## A4LD UPDATE HANDBOOK INDEX

AUTOMATIC TRANSMISSION SERVICE GROUP  
9200 S. DADELAND BLVD. SUITE 720  
MIAMI, FLORIDA 33156  
(305) 670-4161

Figure 10

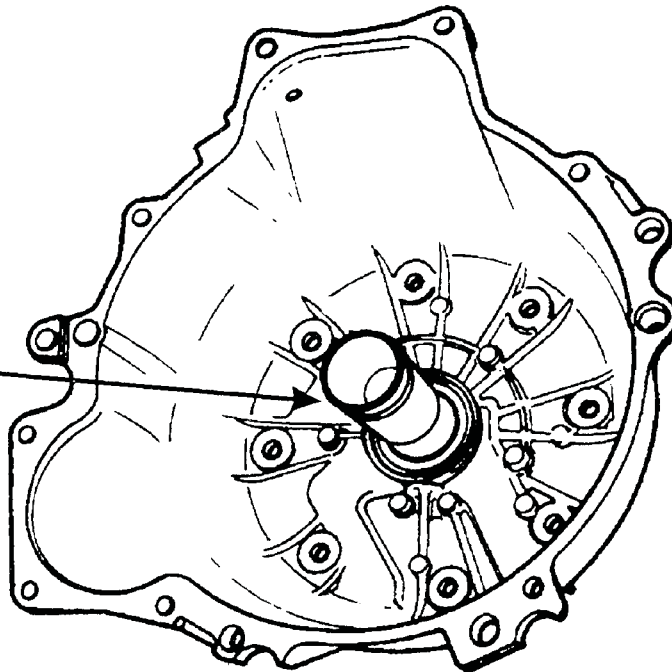
When assembling the pump body to the bell housing, a pump alignment tool must be used (Refer to Figure 10). Using the torque converter, will not produce proper pump alignment. If an alignment tool is not used, several problems may occur, such as:

- (1) PUMP GEARS BREAKING
- (2) PUMP WHINE
- (3) IRREGULAR BUSHING WEAR
- (4) IRREGULAR CONVERTER HUB WEAR
- (5) FRONT SEAL LEAK OR BLOW OUT

Another concern that may be attributed to the above listed problems, is replacement of the front pump bushing in the bell housing. At the factory, Ford puts an oversized bushing in the bell housing and then bores the bushing to the proper size, and establish the centerline. When a new bushing is installed, (possibly off center) pump alignment may not be possible. Ford Motor Company recommends using a new bell housing if bushing replacement is necessary. Aftermarket exchange bell housings with line bored bushings are also available.

PUMP ALIGNMENT  
TOOL  
FORD PART NUMBER  
T74P-77103-X

Figure 21

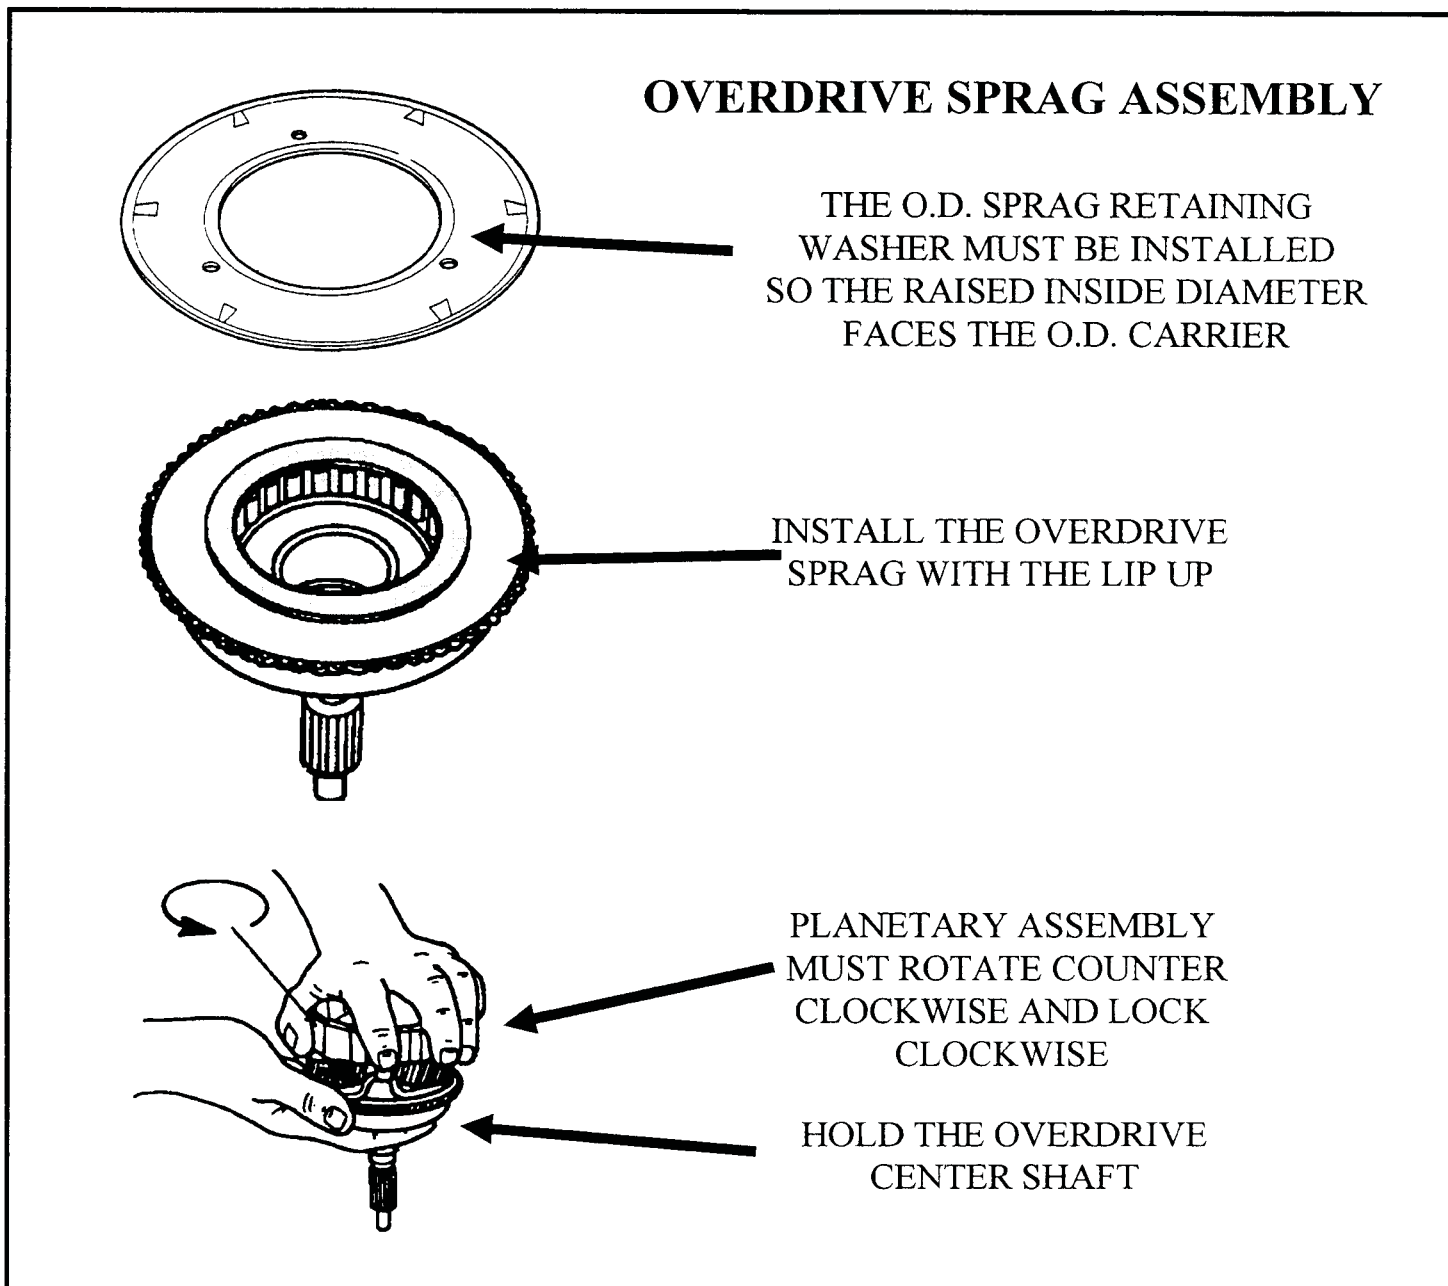
**COMPLAINT:** Vehicle will not move in the overdrive range, but will move in D3, 2, and 1. Another common complaint is a flair-up on a 4-3 kick down.

**CAUSE:** The cause may be the overdrive sprag in backwards or not holding (See Figure 21).

**CORRECTION:** Replace the overdrive sprag, and inspect the inner and outer sprag races for wear or damage.

Figure 28

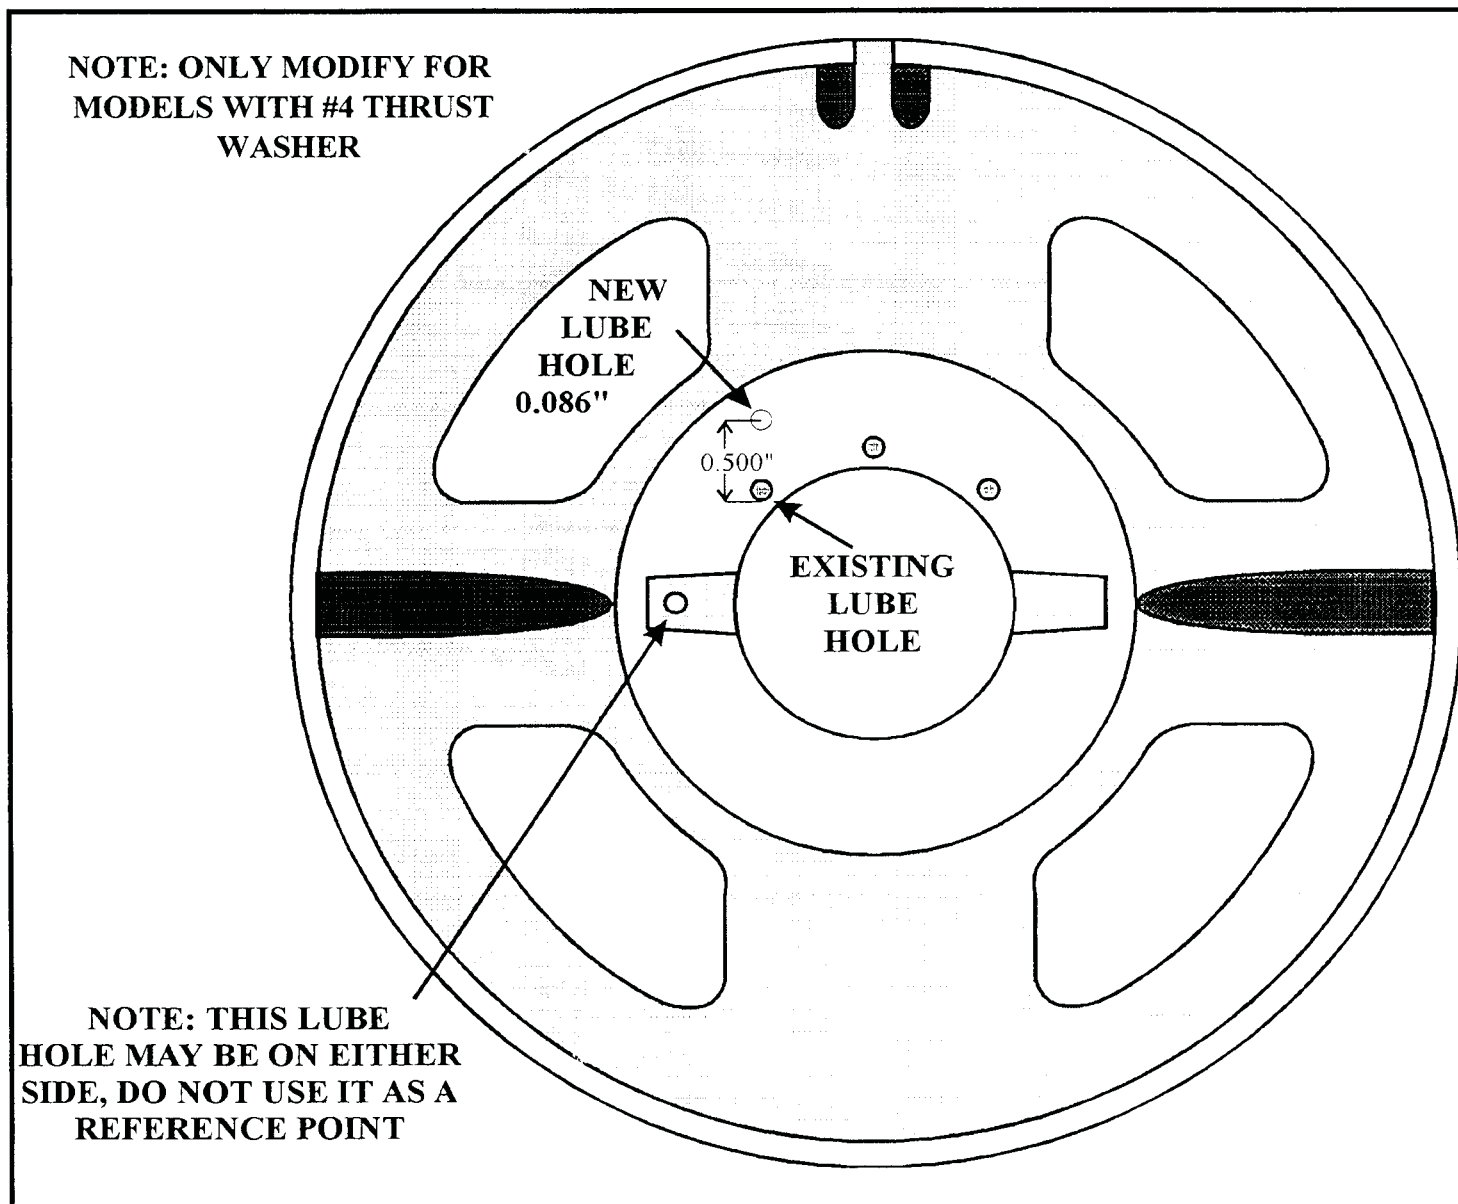
**COMPLAINT:** Failure of the selective #4 thrust washer between the center support and the direct drum.

**CAUSE:** The cause may be lack of lubrication to the #4 thrust washer.

**CORRECTION:** Drill a new lube hole in the center support. Measure 0.500" up from the bottom of the existing hole, drill a 0.086" hole all the way through the center support (See Figure 28).

## INTERCHANGEABILITY:

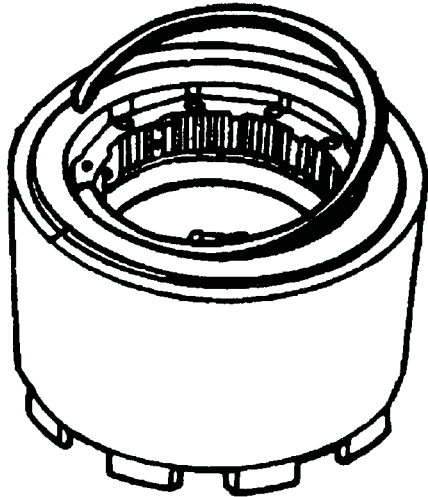
- (1) The **1st Design 3 pinion aluminum** front planetary carrier system, as shown in Figure 43, is recommended for nothing larger than 2.3L engine models. The 1st Design 3 pinion aluminum front planetary carrier is no longer serviced by Ford Motor Co. It now upgrades to the latest 3rd Design 6 pinion steel front planetary carrier system, which comes as a service package and includes all necessary hubs and washers to make it compatible, and is available under OEM part number F0TZ-7A398-E.

- (2) The **2nd Design 4 pinion steel** front planetary carrier system, as shown in Figure 43, with the 1.580" inside diameter ring gear hub, the number 7 thrust bearing, the number 6 "Top Hat" thrust washer **WILL** retro-fit back on all models, except 4.0L engine models, but all parts listed above must be used as an assembly (See Figure 43). The 2nd Design 4 pinion steel front planetary carrier is no longer serviced by Ford Motor Co. It now upgrades to the latest 3rd Design 6 pinion steel front planetary carrier system, which comes as a service package and includes all necessary hubs and washers to make it compatible, and is available under OEM part number F0TZ-7A398-E.

- (3) The **3rd Design 6 pinion steel**, 4.0L engine front planetary system, as shown in Figure 43, with the 1.580" inside diameter ring gear hub, the number 7 thrust bearing, number 6 (3 Piece) thrust bearing, and bushing (7D090) **WILL** retro-fit back on all previous models, but the parts listed above are **mandatory on 4.0L models** (See Figure 43).

Figure 46

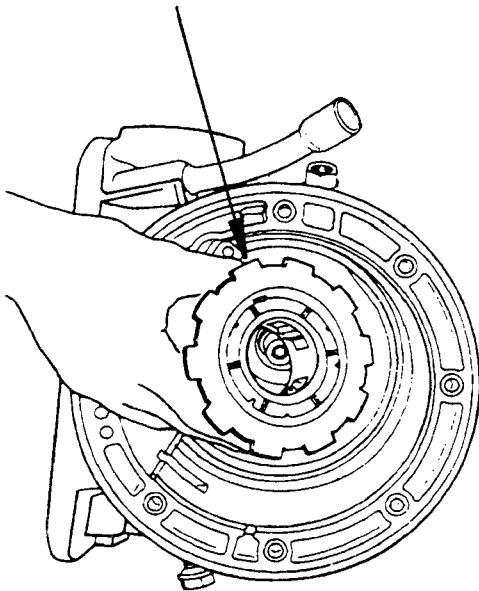
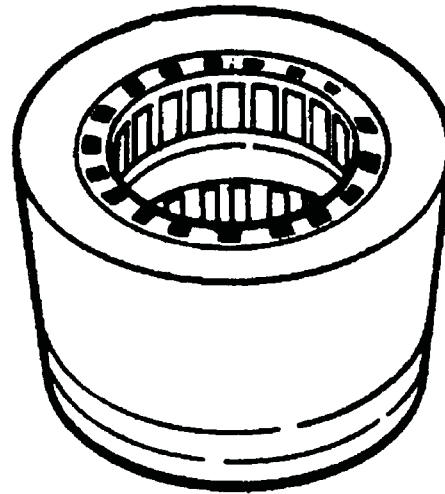
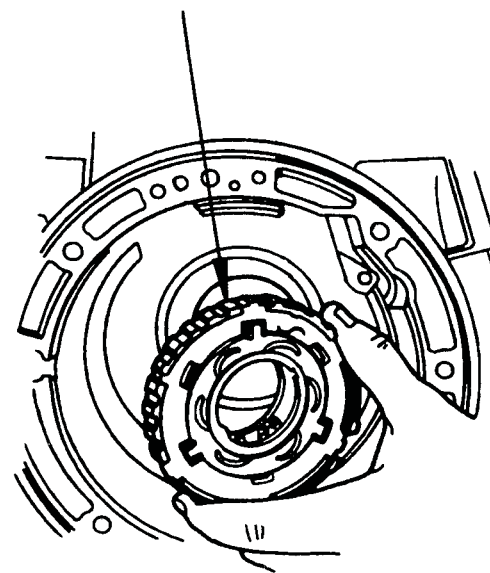
**"1ST DESIGN"  
REVERSE DRUM  
WITH ROLLER CLUTCH**

**REQUIRES THE "2ND DESIGN"  
10 LUG REAR CARRIER**

**"2ND DESIGN"  
REVERSE DRUM  
WITH SPRAG**

**REQUIRES THE "3RD DESIGN"  
MULTIPLE LUG REAR CARRIER**

Figure 70

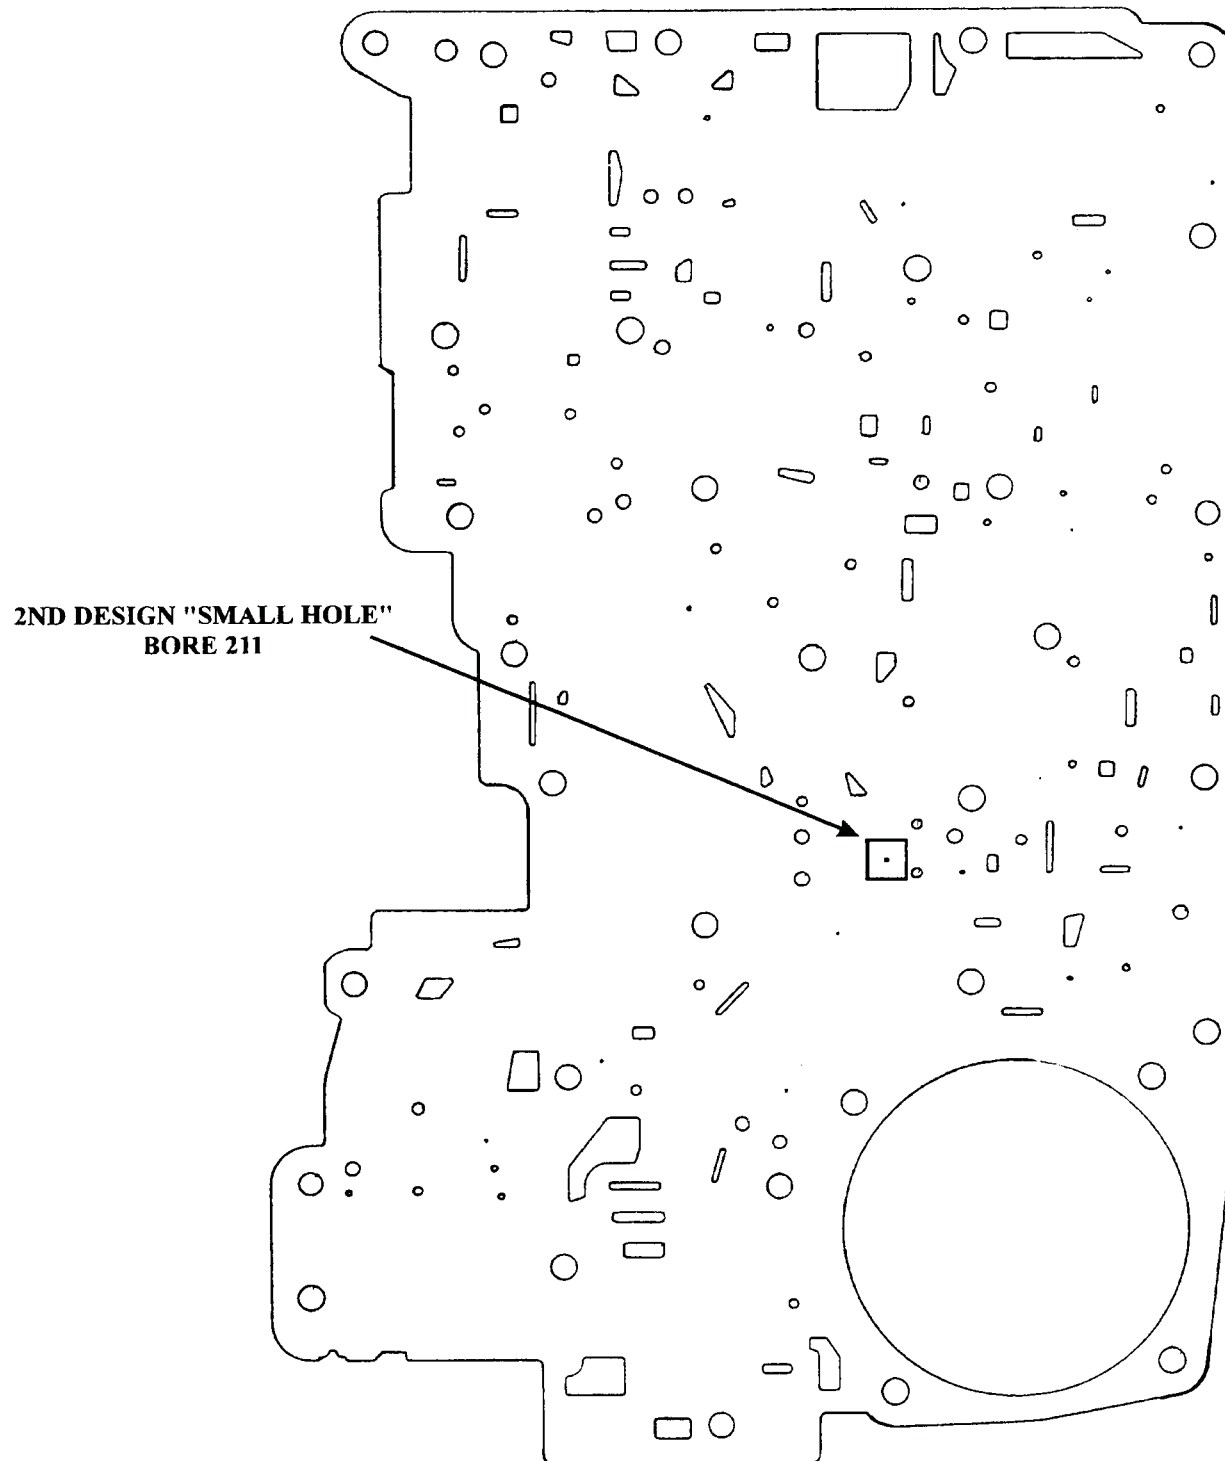
The 2nd design valve train has eliminated two springs and incorporated two spool valves into one, as shown in Figure 69. Figure 70 shows the "Small Hole" spacer plate that is required with the 2nd design line-up in bore 211.

## "SMALL HOLE" SPACER PLATE REQUIRED WITH 2ND DESIGN BORE 211 (1-2 TRANSITION VALVE)

Figure 81

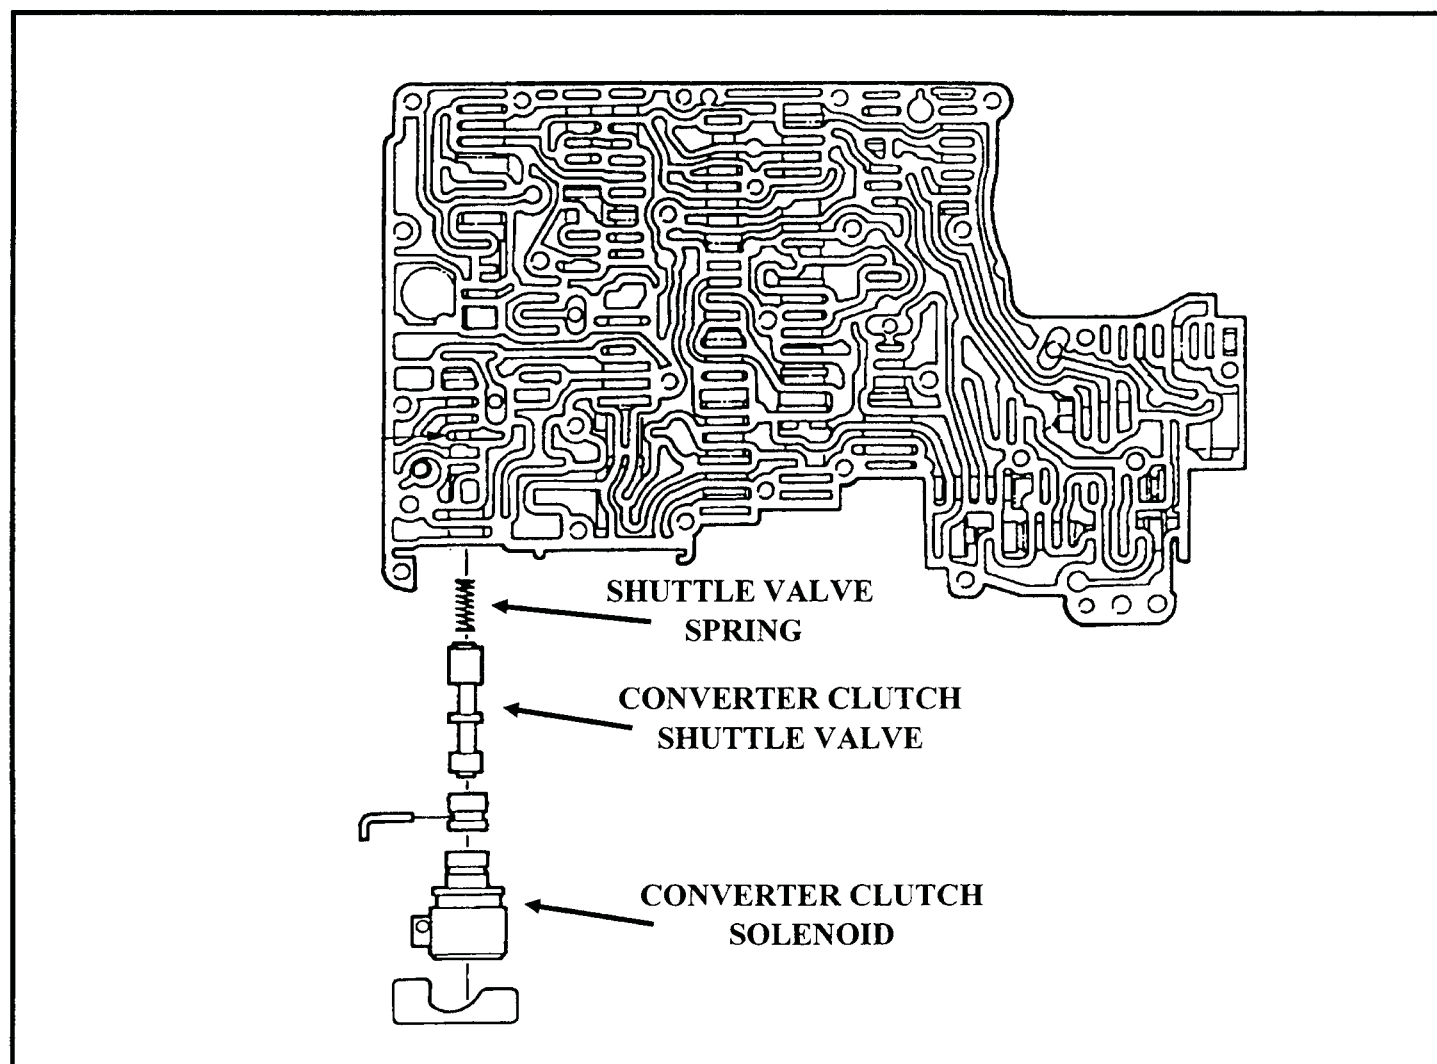
**COMPLAINT:** Engine stalls when the selector is placed into forward or reverse.

**CAUSE:** The cause may be a broken converter clutch shuttle valve spring.

**CORRECTION:** Replace the broken converter clutch shuttle valve spring with updated spring (See Figure 81).

Shuttle Valve Spring.....E5TZ-7L490-A
